Town of Milford Meeting Notice

Board or Commission: Conservation Commission

Date and Time of Meeting: Wednesday November 18, at 7.00 P. M

1 NATIONAL STREET
AS-BUILT PLAN OF LAND
MILFORD, MASSACHUSETTS
PREPARED FOR
DACION CORPORATION

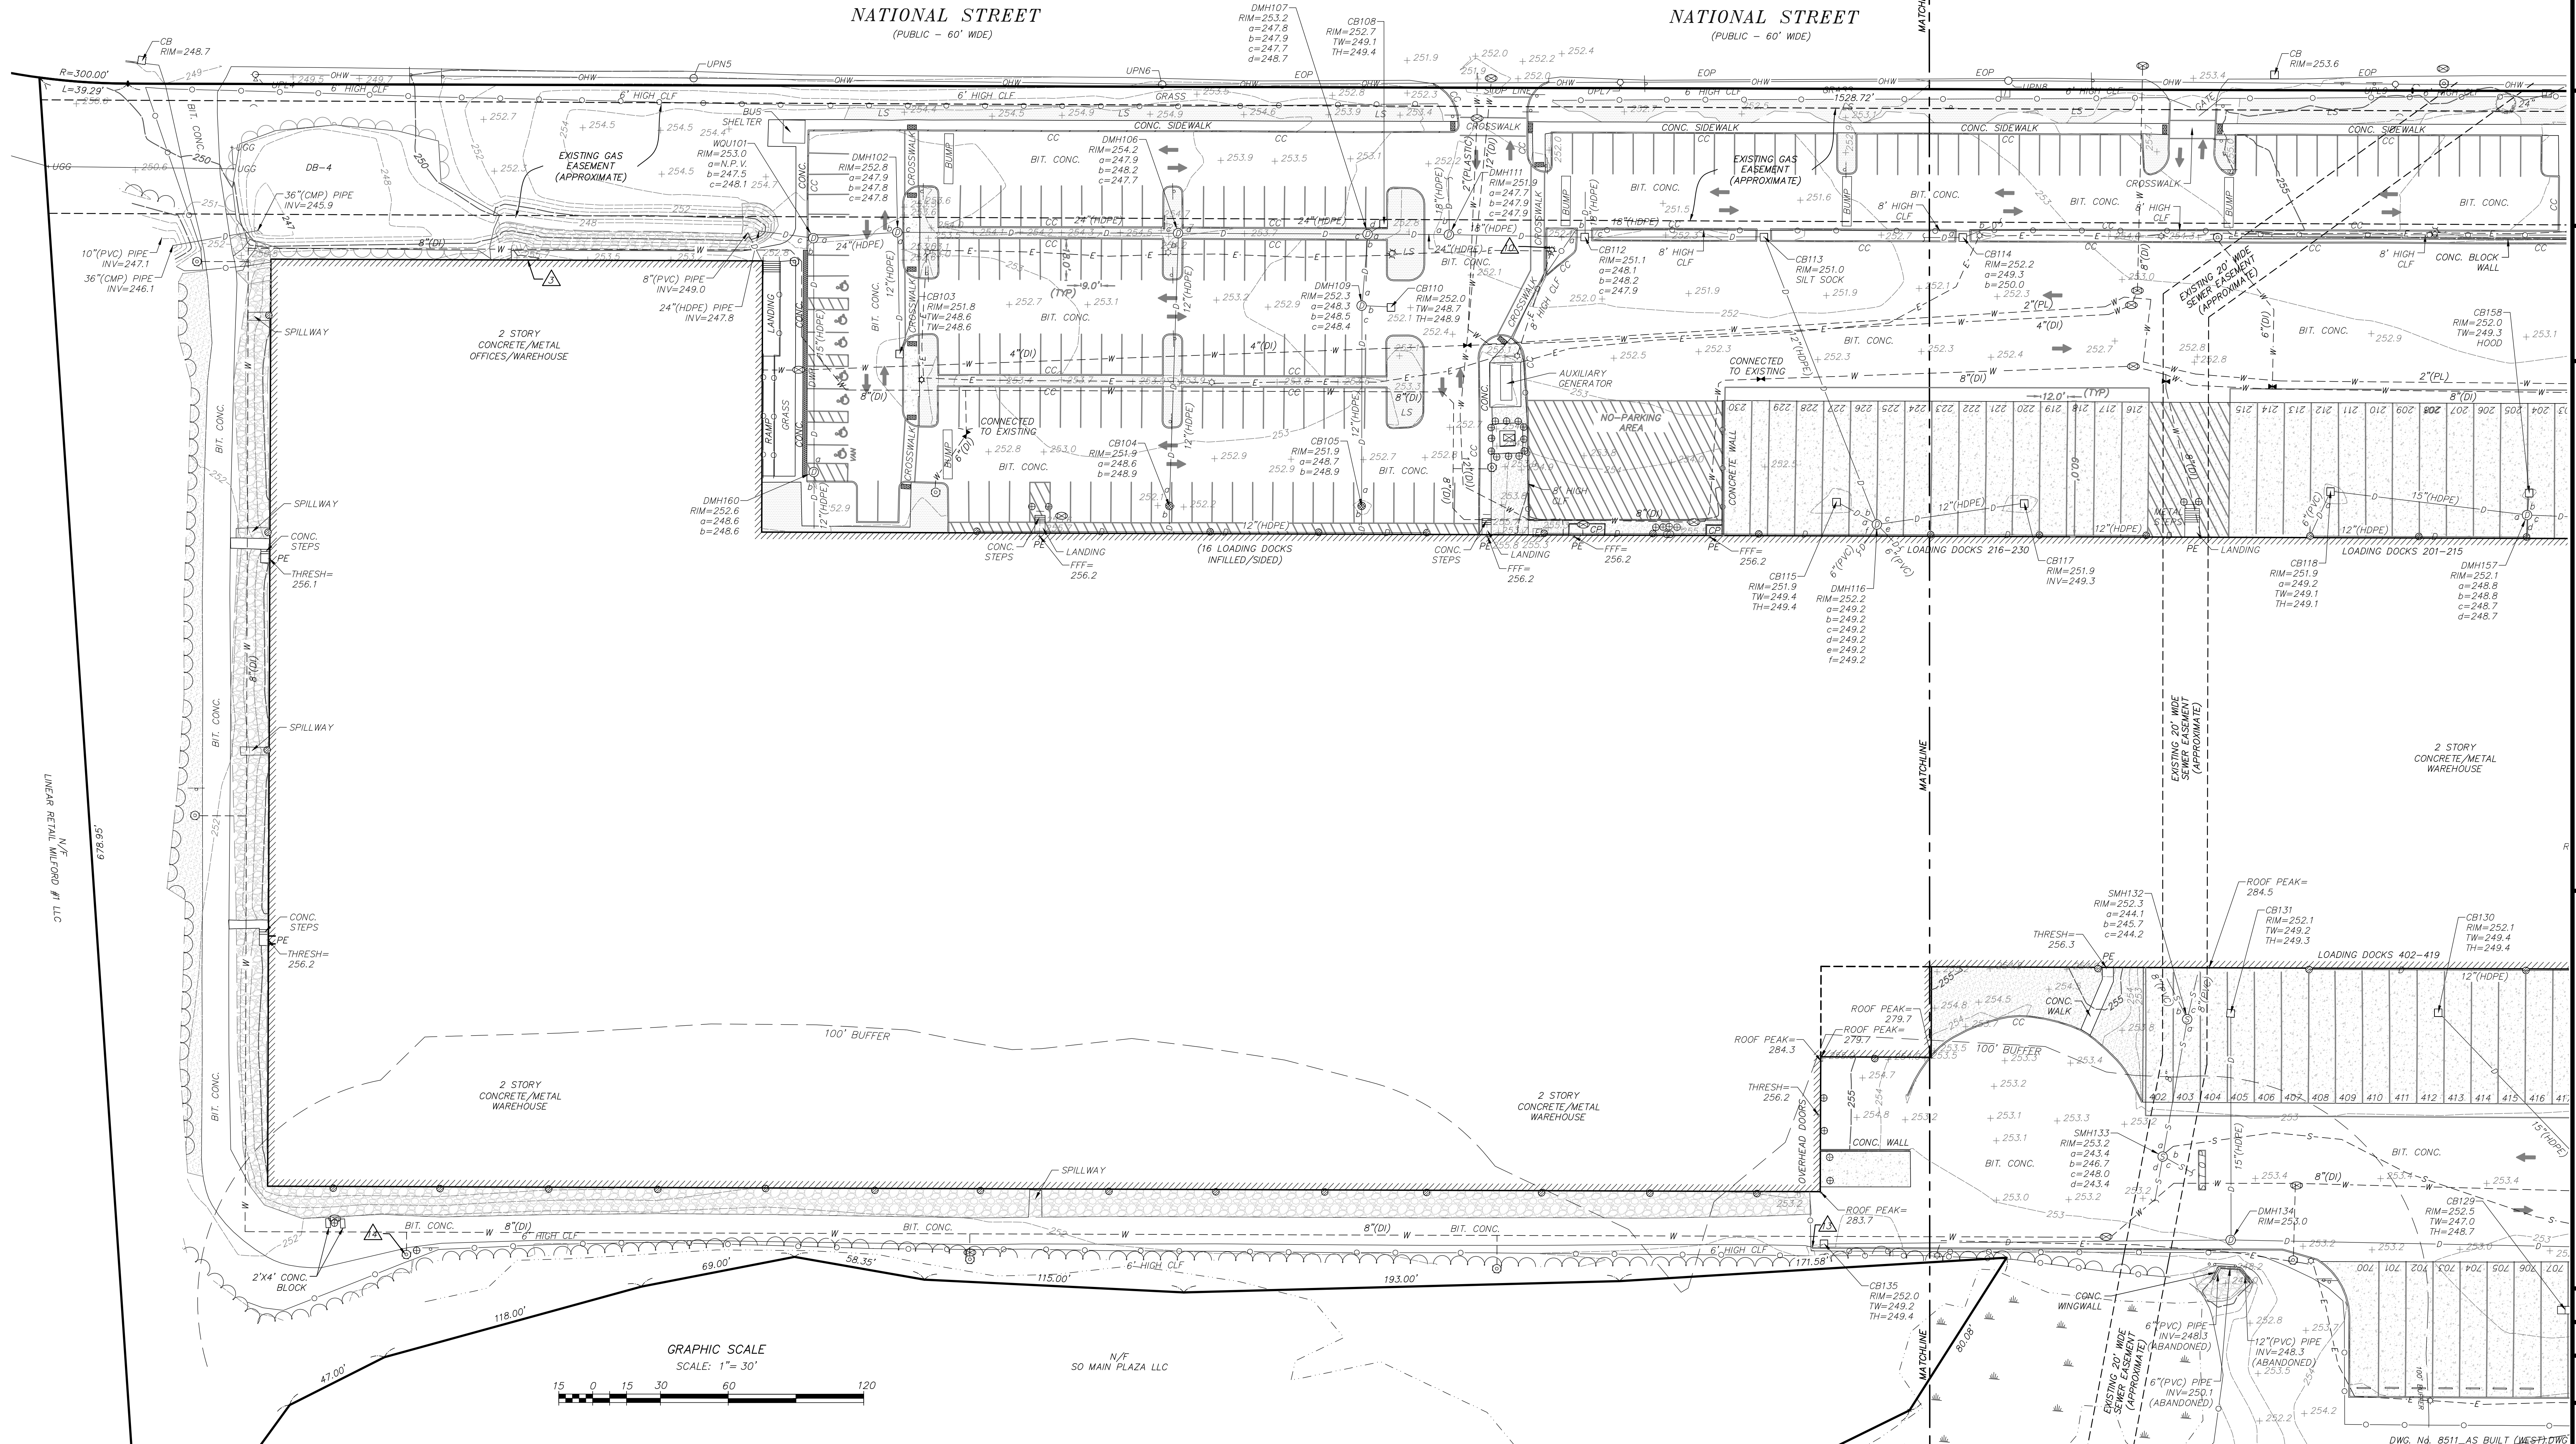
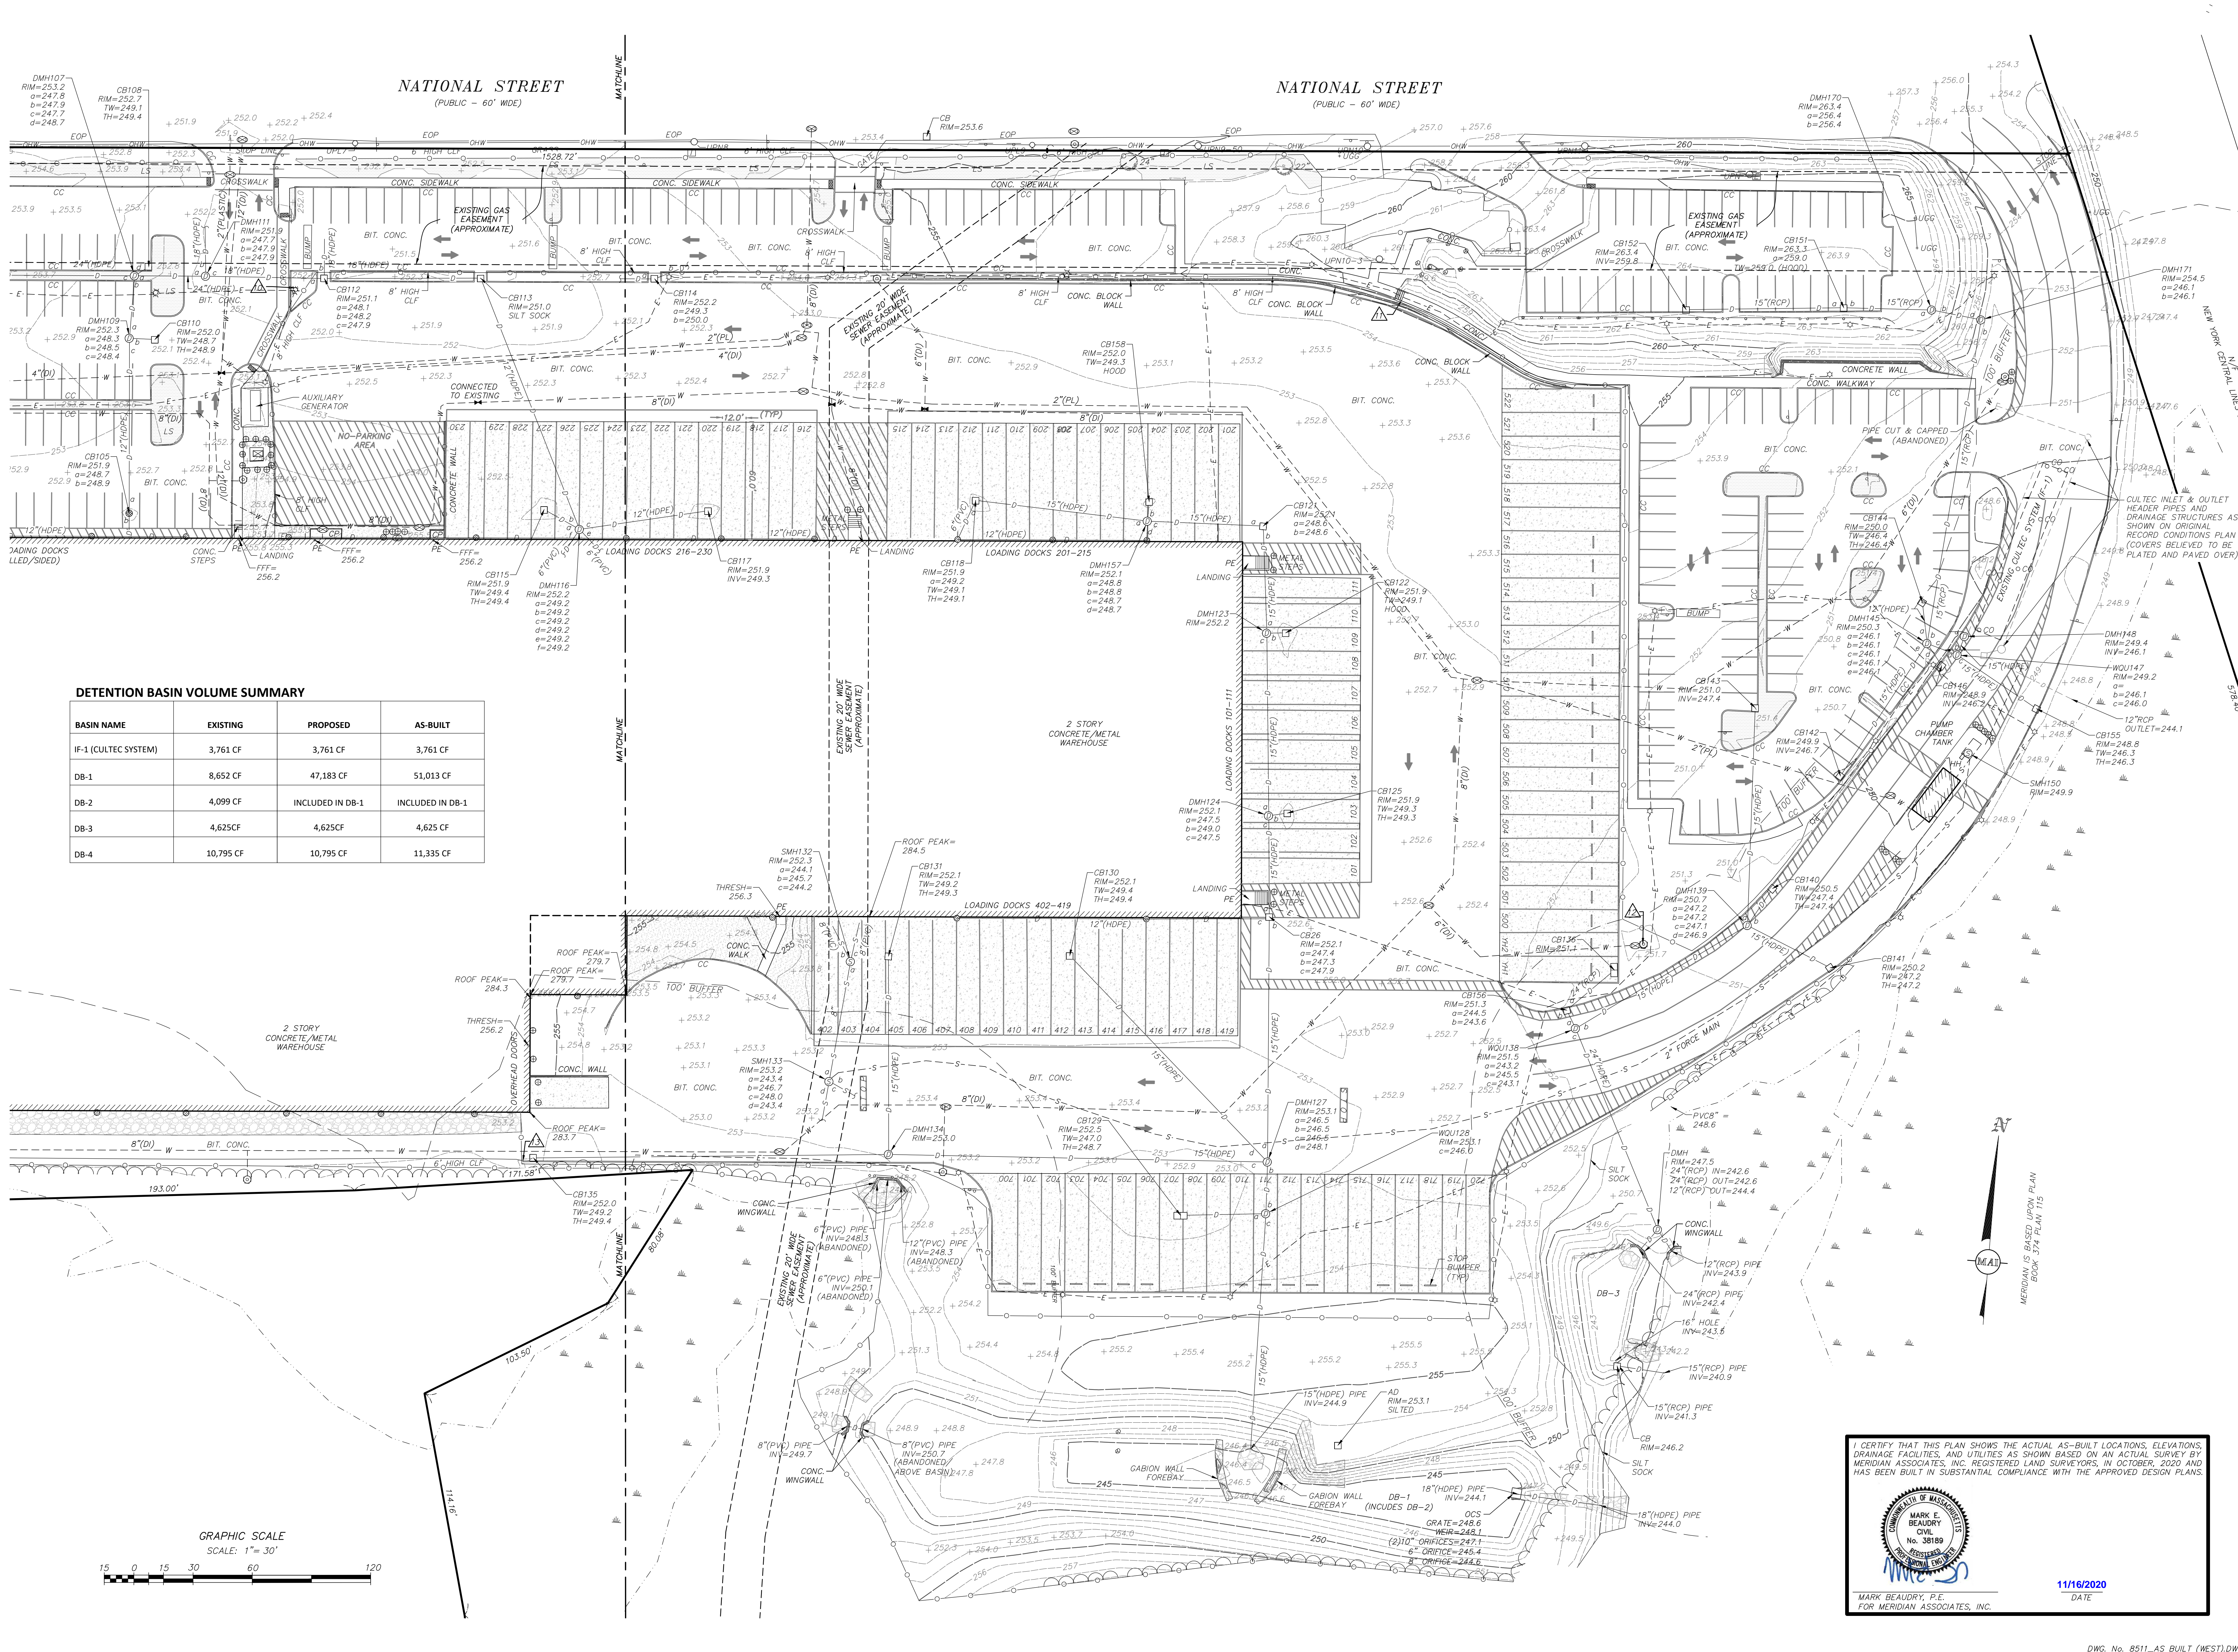
Following a site inspection, it was discovered a couple of the drainage structures have been paved over. These structures are associated with the drainage located in the eastern portion of the site, in the main truck entrance off of the end of National Street. I recommend the two or three structures have rims and covers installed and that they are brought to existing grade.

I recommend the issuance of the Certificate of Compliance (COC) and to hold the COC until a final inspection is performed on the above-mentioned drainage structures and the as-built plan is updated.

NO.	DATE	REVISIONS	DESCRIPTION
1	11/16/20		CONSERVATION SITE WALK COMMENTS
